Project	<b>IEEE 802.16 Broadband Wireless Access Working Group</b> < <a href="http://ieee802.org/16">http://ieee802.org/16</a> >
Title	<b>Harmonized Relay Frame Structure</b>
Date Submitted	<b>2009-01-05</b>
Source(s)	<p>Jerry Sydir, Alexander Maltsev, <a href="mailto:jerry.sydir@intel.com">jerry.sydir@intel.com</a>  Honggang Li, Alexei Davydov, Rui Huang  Intel Corporation</p> <p>Rakesh Taori, Youngbin Chang <a href="mailto:rakesh.taori@samsung.com">rakesh.taori@samsung.com</a>  Samsung Electronics</p> <p>Shashikant Maheshwari, Adrian Boariu, <a href="mailto:shashi.maheshwari@nsn.com">shashi.maheshwari@nsn.com</a>  Yousuf Saifullah  Nokia Siemens Networks <a href="mailto:lsun@lge.com">lsun@lge.com</a></p> <p>Li-Hsiang Sun , Ki-Dong Lee, Aeran Youn  LG Electronics</p> <p>Yuqin Chen, Yang Liu, Hongyun Qu, <a href="mailto:chen.yuqin@zte.com.cn">chen.yuqin@zte.com.cn</a>  Mary Chion <a href="mailto:liu.yang8@zte.com.cn">liu.yang8@zte.com.cn</a>  <a href="mailto:qu.hongyun@zte.com.cn">qu.hongyun@zte.com.cn</a>  <a href="mailto:mchion@zteusa.com">mchion@zteusa.com</a>  ZTE Corporation</p> <p>*&lt;<a href="http://standards.ieee.org/faqs/affiliationFAQ.html">http://standards.ieee.org/faqs

Figure 33 Relay Frame structure ~~option 1~~

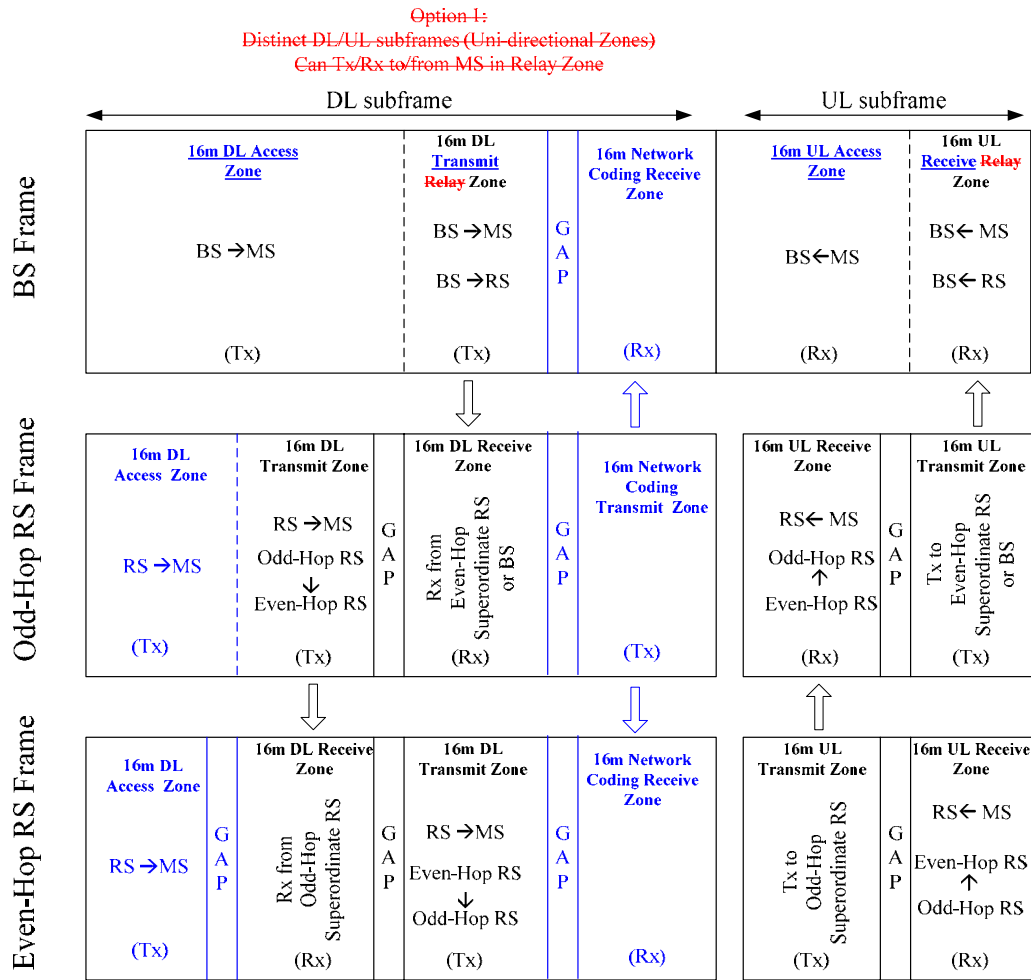
~~There are two options for the Relay frame structure. These are captured in Figure 33 and Figure 34. Further study is required to distill a single frame structure from among these two options. The Relay frame structure is illustrated in Figure 33.~~

*[Modify figure 33 on page 68 as indicated below]*

[Modify the caption of figure 33 on page 68 as indicated below]
